Planning Report

Means/Griffith Property

Case Summary

Agenda Item	1
Case Number	15-030INF
Site Location	7540 and 7660 Hyland-Croy Road East side of Hyland-Croy Road across from the Glacier Ridge Metro Park, south of Brand Road.
Proposal	A potential residential development of a 48-acre site including two concepts for development for single-family lots of varying sizes with up to 75 lots and up to 21 acres of open space.
Request	Informal review and feedback for a potential development prior to a future rezoning application.
Owner/Applicant	Matt Callahan, Pulte Homes of Ohio, LLC, represented by Thomas L. Hart, Esq. Isaac Wiles Burkholder & Teetor, LLC.
Case Manager	Claudia D. Husak, Planner II (614) 410-4675 chusak@dublin.oh.us Marie Downie, Planner (614) 410-4679 mdownie@dublin.oh.us
Planning Recommendation	Discussion and Feedback

Concept A

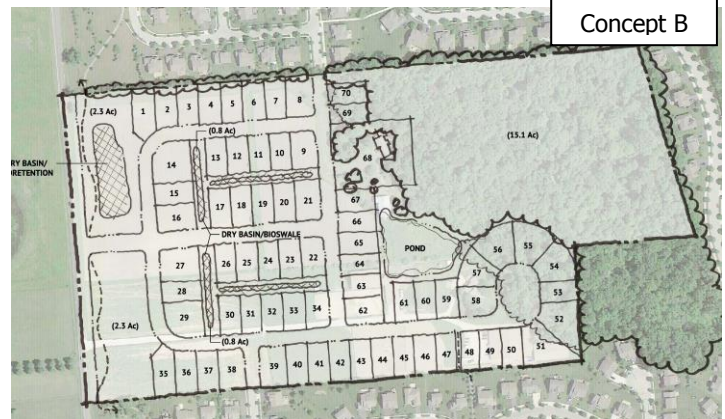
Concept A contains 75 lots and approximately 20 acres of open space for a density of 1.55 du/ac.

Access to the site from Hyland-Croy is shown at the north west corner. Connections to Bishop's Crossing and Park Place subdivisions are shown off Mill Springs Drive and Barrister Drive.

Two stormwater management ponds are shown in the southwest portion of the site, near the existing wooded area. A road ending in a cul-de-sac is shown to cross the ponds and extends deeply into the woods at the east side of the site to provide access to 18 lots. The buffer along Hyland-Croy has 4.7 acres of open space and the preservation of the existing wooded area equals 11.3 acres.

The lot depths are shown at 135 feet varying lot widths. The plan shows:

- six 80-foot wide lots;
- 39 75-foot wide lots; and
- 29 70-foot wide lots.

Significant tree removal will be needed for Lots 56-73. The plan keeps a wooded perimeter of approximately 11 acres, the south portion of which can be incorporated into the existing Post Preserve park.
